Product Change Notice (PCN)

PCN Number: **PCN-0451213R-01**

Product(s) Affected: **PJ-059BH**

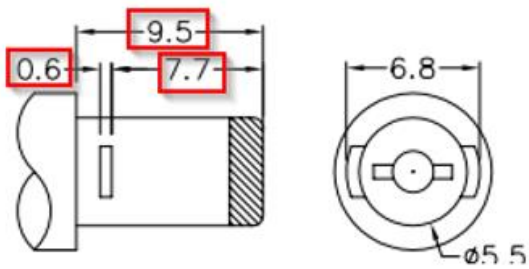
Description of Change: **Minor Housing and footprint differences. Material Change on the housing and terminals. See image Below**

PREVIOUS CUI DEVICES DETAIL / IMAGE			NEW CUI DEVICES DETAIL / IMAGE		
	MATERIAL	PLATING	DESCRIPTION	MATERIAL	PLATING/COLOR
center pin	copper	nickel	center pin	brass	nickel
terminal 1	brass	silver	terminal 1	brass t=0.30	silver
terminal 2	copper alloy	silver	terminal 2	bronze t=0.25	silver
terminal 3	brass	silver	terminal 3	brass t=0.30	silver
plastic	PBT		cover	PBT (UL94V-0)	black
			housing	PBT (UL94V-0)	black

MATING PLUG
Jack Insertion Depth: 9.8 mm

MATING PLUG
Jack Insertion Depth: 9.5 mm
